Model: DI-C1 Internal Finisher Type C2550	Date: 24-Dec-09	No.: RD429001a
---	-----------------	----------------

Subject: Parts Catalog Correction		Prepared by: M.Saiki	
From: 2nd Overseas Tech Support Sec., 2nd PQM Dept.			
Classification :	☐ Troubleshooting	☒ Part information	☐ Action required
	☐ Mechanical	☐ Electrical	☐ Service manual revision
	☐ Paper path	☐ Transmit/receive	☐ Retrofit information
	☐ Product Safety	☐ Other ()	☐ Tier 2

Model: DI-C1 Internal Finisher Type C2550		Date: 09-Apr-10	No.: RD429002
Subject: SC742 (stapler motor error)		Prepared by: M.Saiki	
From: 2nd Overseas Tech Support Sec., 2nd PQM Dept.			
Classification:	☒ Troubleshooting ☐ Mechanical ☐ Paper path ☐ Product Safety	☐ Part information ☐ Electrical ☐ Transmit/receive ☐ Other ()	☐ Action required ☐ Service manual revision ☐ Retrofit information ☒ Tier 2

Model: DI-C1 Internal Finisher Type C2550		Date: 13-Apr-10	No.: RD429003
Subject: Parts Catalog Correction_Harness and Connector		Prepared by: M.Saiki	
From: 2nd Overseas Tech Support Sec., 2nd PQM Dept.			
Classification:	☐ Troubleshooting ☒ Part information ☐ Action required ☐ Mechanical ☐ Electrical ☐ Service manual revision ☐ Paper path ☐ Transm

3.Bridge Unit 1 (D429)

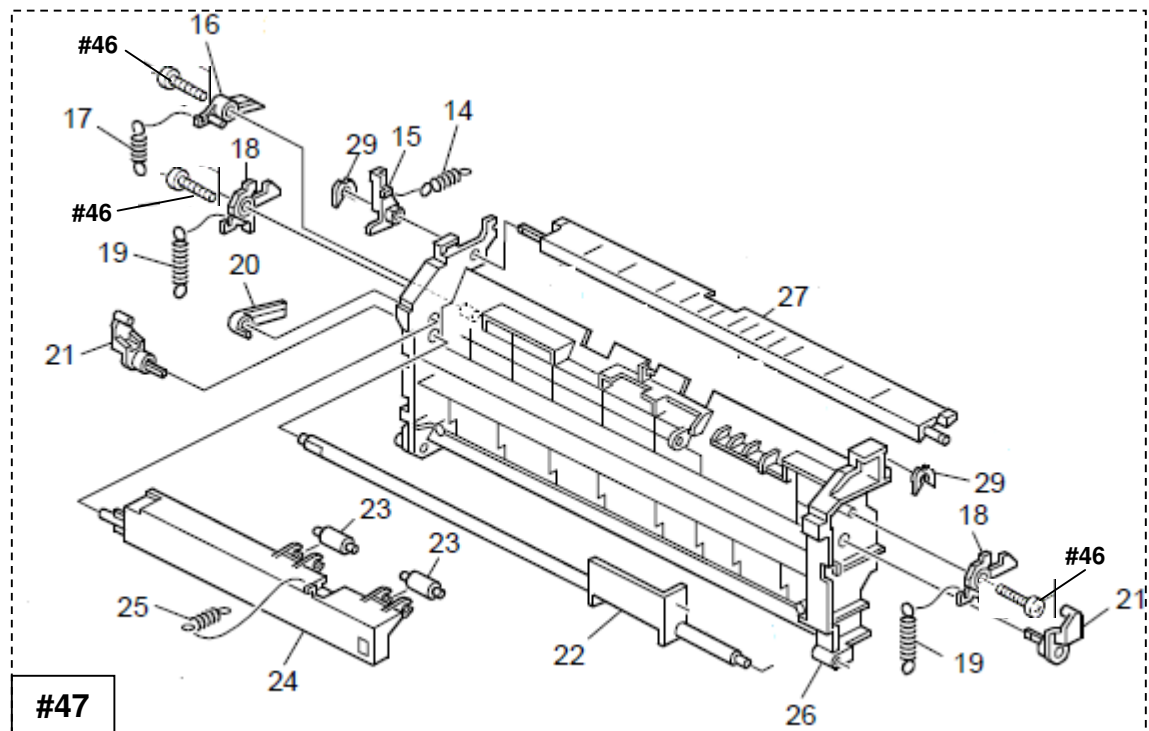
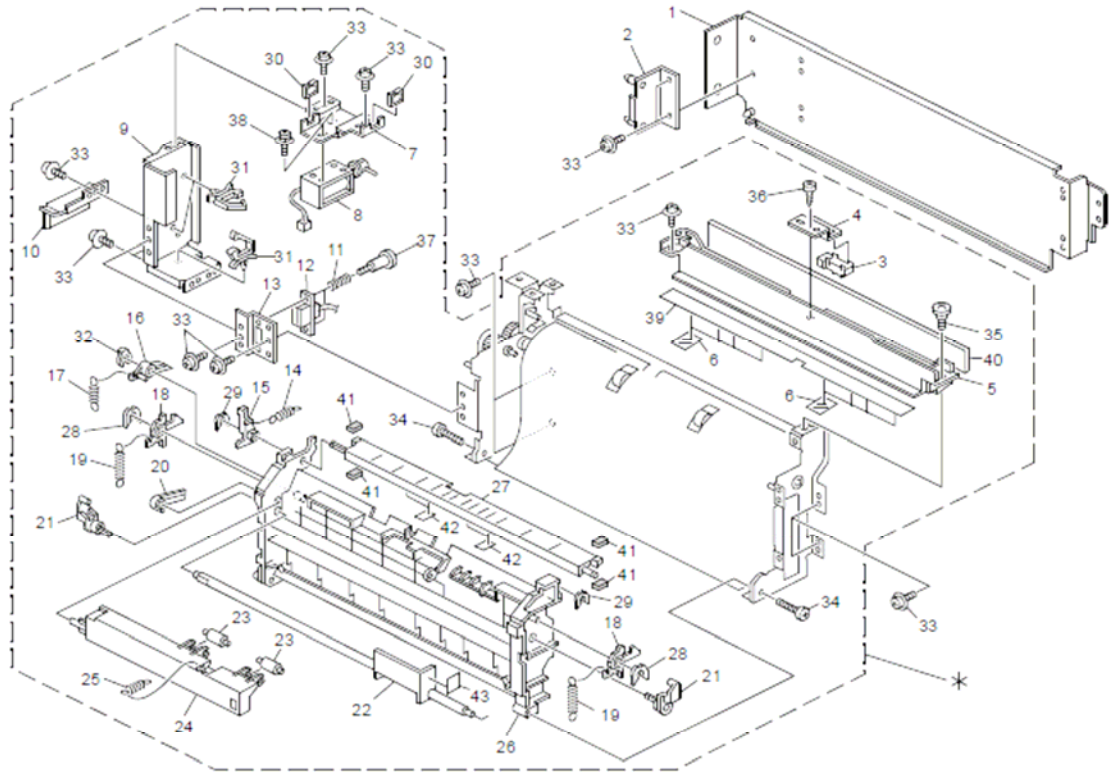
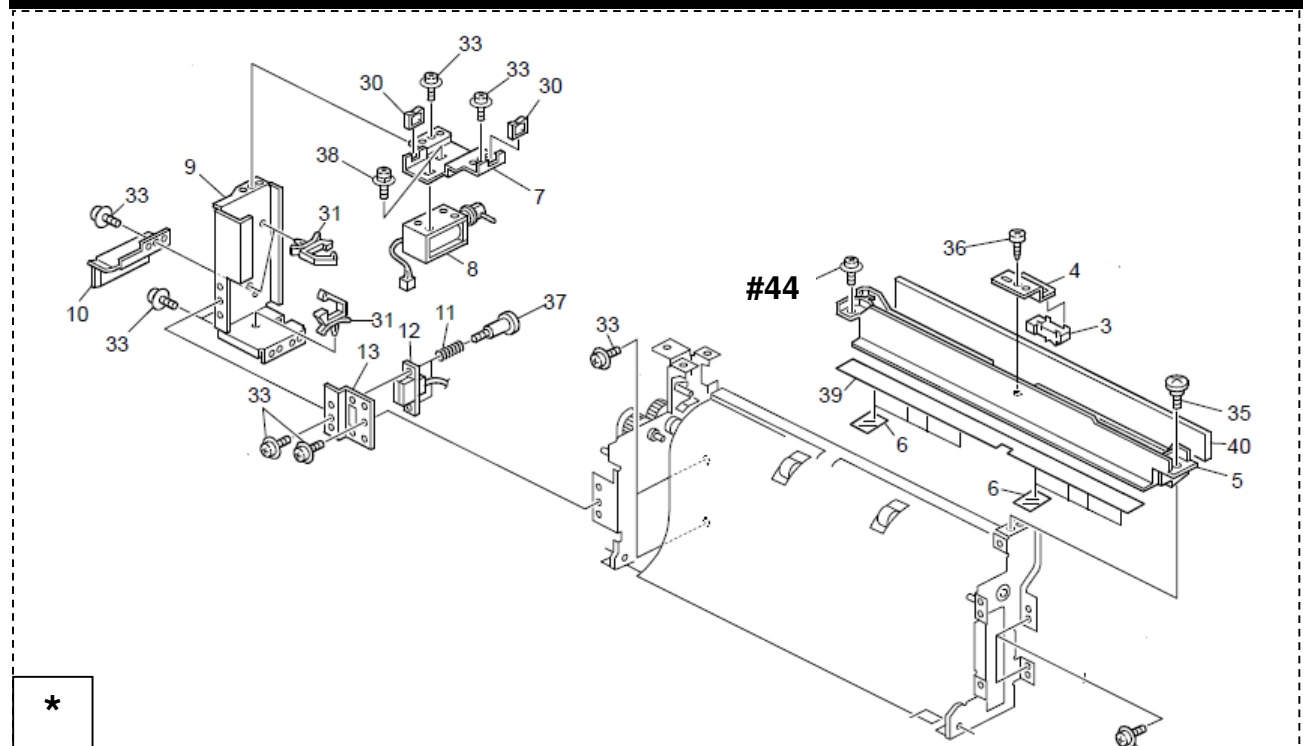
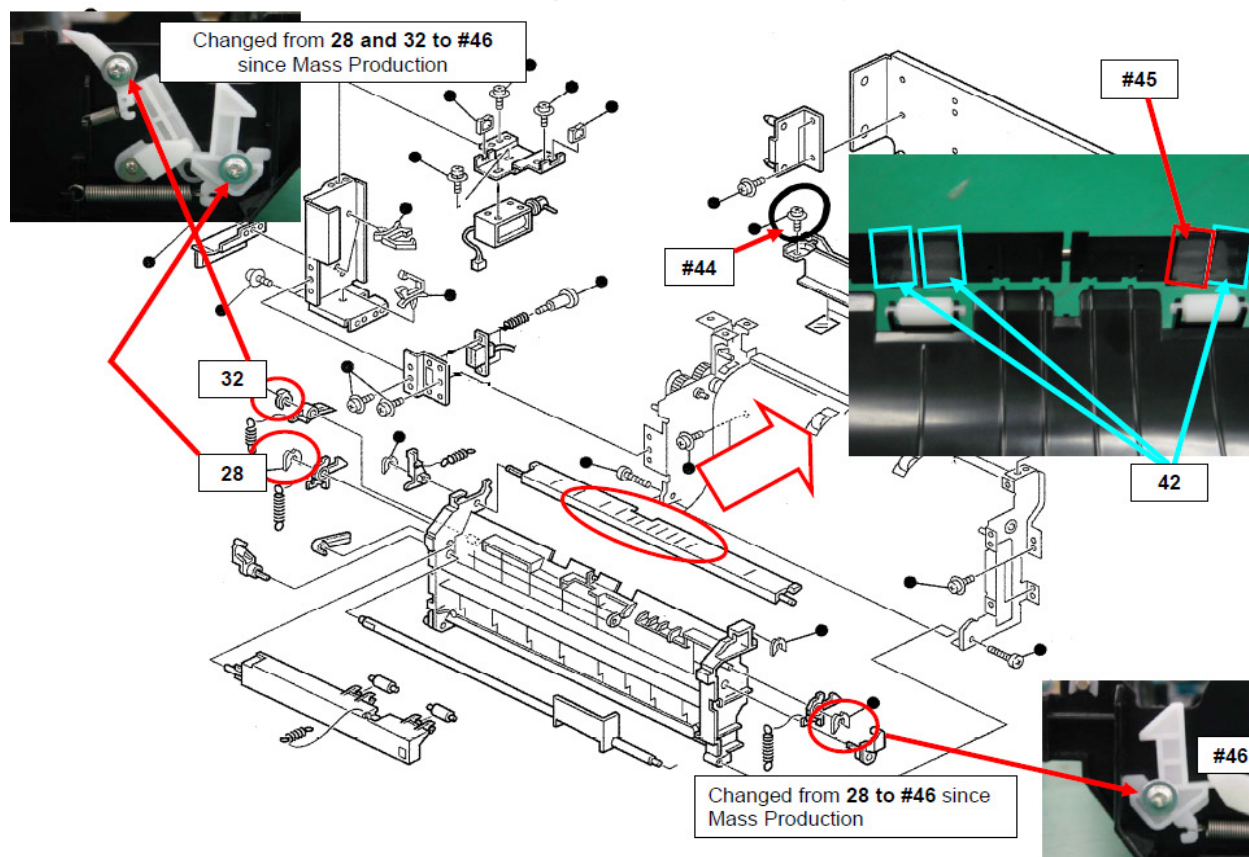
Incorrect part number	Correct part number	Description	Q'ty	Int	Page	Index	Note
B7920001		TAPPING SCRER:030060FWTP	14 - 13		7	33	
	D4292105	TAPPING SCRER:PF4143P338A1	0 - 1	X/O	7	#44	
D4292147	D4292106	DC SOLENOID:PF4160K150A	1 - 1	X/O	7	8	
D4292150	D4292108	CONNECTOR:PF4160K326A1	1 - 1	X/O	7	12	
D4292151		SHEET:GATE PAWL:PF4160P329	4 - 3		7	42	
	D4292155	GATE PLATE:PF4160P335B1	0 - 1	X/O	7	#45	
B7920019		END RING:NS-CLP00005	2 - 0		7	28	
B7920027		END RING:NS-CLP00003	1 - 0		7	32	
	D4292154	SCREW:NS-SCR00084B	0 - 3	X/O	7	#46	
	D4292103	REVERSE UNIT:PF4160K147	0 - 1		7	#47	
D4292148	D4292107	DC SOLENOID:PF4160K340A	1 - 1	X/O	9	6	
D4292149	D4292104	ENTRANCE SENSOR:E314000852	1 - 1	X/O	7	3

Old part number	New part number	Description	Q'ty	Int	Page	Index	Note
D4292101	D4292102	REVERSE UNIT:PF4160K142	1 - 1	O/O	7	*

Change: The indexes of the illustration were changed.

Reason: Correction of the illustration and part numbers

See the diagrams on the next page for the corrected illustrations.

P/N A2579300 Grease Barrierta – S552R

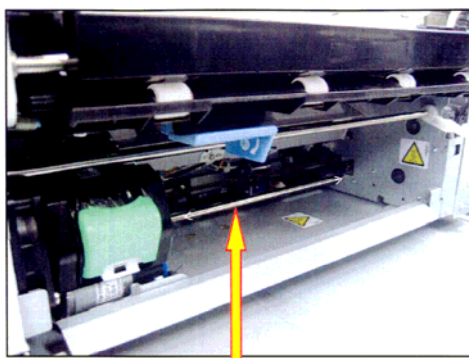
SC742 (finisher stapler motor error)

The friction between the stapler unit shaft and its bushings is too high, which prevents the stapler unit from operating smoothly.

If the symptom is reported, apply the following grease to the shaft:

- Apply the amount of grease shown in the photograph (which just covers the head of a small flathead screwdriver).

- Apply the grease to the shaft shown in the photo below. Move the stapler unit carefully so that you can apply the grease evenly across the shaft. And verify if the guide plate doesn't rub the front plate. If so, push it gently inside to avoid friction.

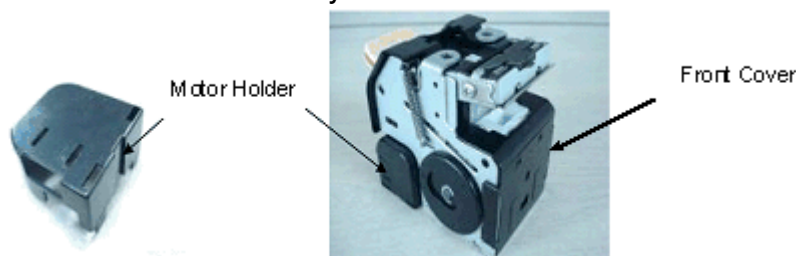
Some parts of the stapler unit (black resin parts shown below) contained PBDE material in excess of the limits set by the RoHS Directive.

The vendor of these parts used irregular materials during the manufacturing process.
 Production period: June to September 2010 (refer to the S/N table below)

Replace the stapler unit.

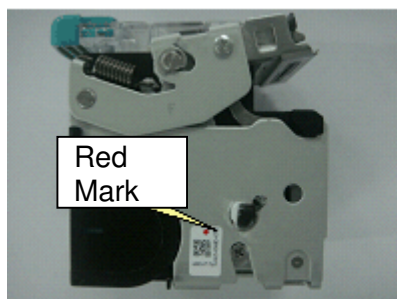
Important: Stapler units on some of these affected finishers have already been replaced with the normal ones. If there is a **red dot** on the stapler unit's label (see the photo below), you **do not need to replace** these units.

The affected stapler unit is shown in the illustration below (Index #24):

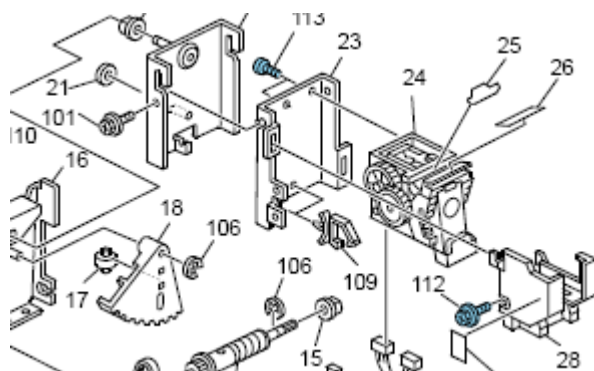
2. Stapler units for corner stapling on the affected finishers with the parts that were registered specifically for this issue (also listed below). So, this issue does not apply to booklet stapler units (B7007852), so you do not need to replace these.

Finisher	Stapler unit P/N
SR790	B408 9910
SR3000	B793 9901
SR3050	D372 9901
SR3020*(see note2)	B805 9901
SR3030	
SR4020*(see note2)	
SR4030	
SR4040*(see note2)	
SR3010	B792 9901
Internal Finisher Type C2550	D429 9910
